RE: Bransfield Tree Company  
63 & 65 White Pond Road  
Major Modification

- Earth Removal Special Permit
- Contractors Yard and Erosion Control Special Permit
- Site Plan Approval

Hannigan Engineering, Inc. is in receipt of comments from Places Associates, Inc. dated September 8, 2023 along with public comments relative to the proposed modification of a Special Permit for Contractor's Yard at 63 and 65 White Pond Road in Stow, Massachusetts. We offer the following responses to their comments:

**Vehicle Trip Ends vs: Employees  
On a Weekday**

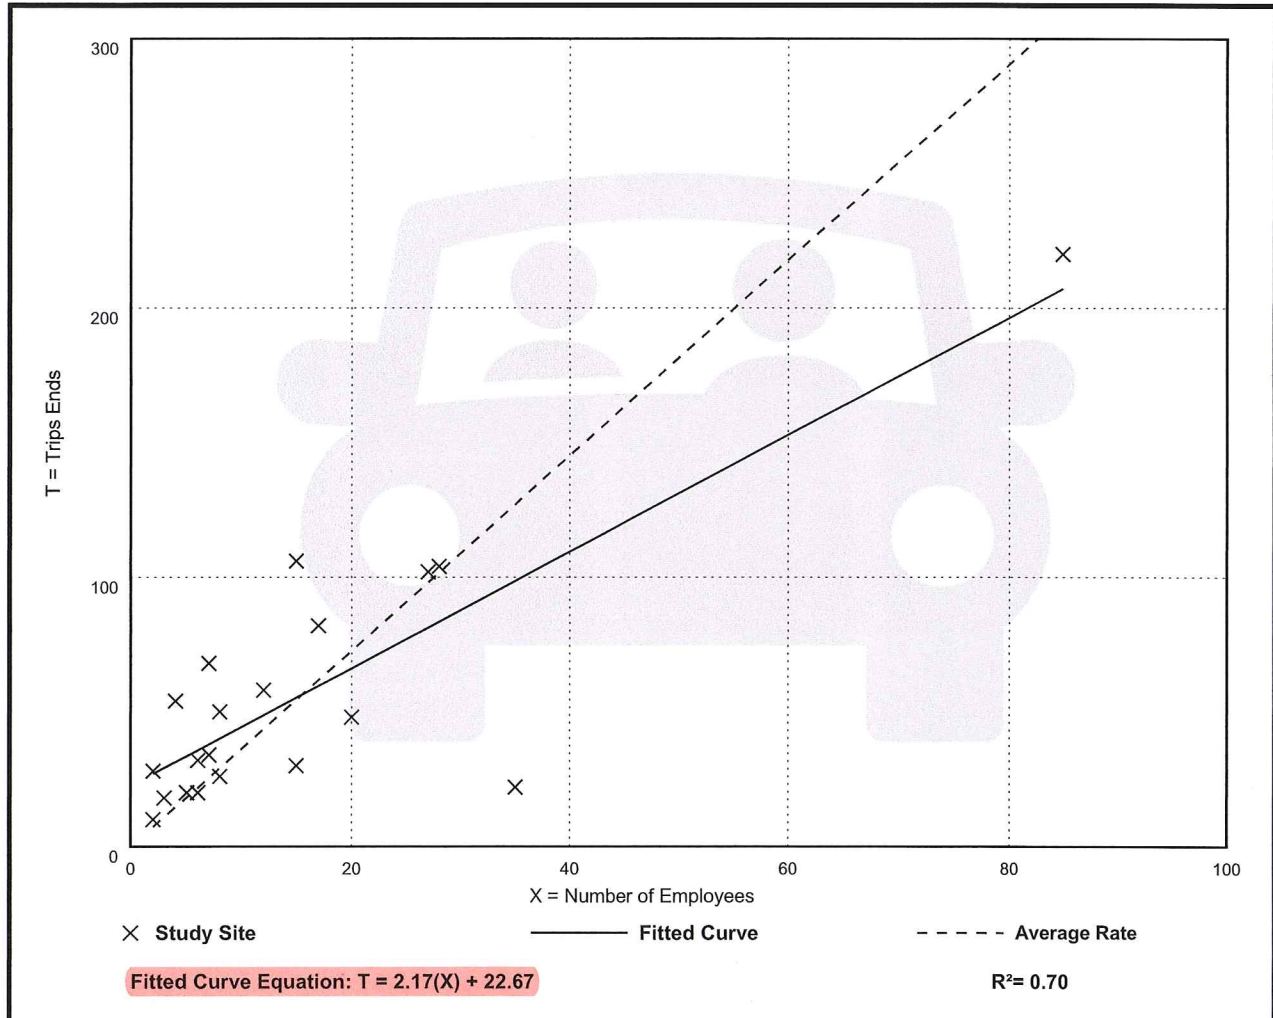
*Comment#6: The application indicated that there would be no change in the proposed traffic generated between the initial 1.5 acre site development and the current proposal with at least 9 companies using the site. We disagree, the more intense use of the site with multiple companies presents the potential for more traffic and should be addressed accordingly for both passenger vehicles as well as company vehicles*

**Response: An updated traffic review has been performed utilizing ITE Trip Generation Manuals which outline anticipated trips generated by an intended use. Based on the current *ITE Trip Generation Manual 11<sup>th</sup> Edition- Land Use 180 – Specialty Trade Contractor*, it is expected that the daily trips per day would be 75 trips per day, with 15 trips during the morning peak hour and 16 trips during the afternoon peak hour based on the permissible 24-employee count on the property. Thus, below the 100 trip per day threshold.**

**Employee Count: 24 ; 2.17(24) + 22.67 = 74.75 Trips**
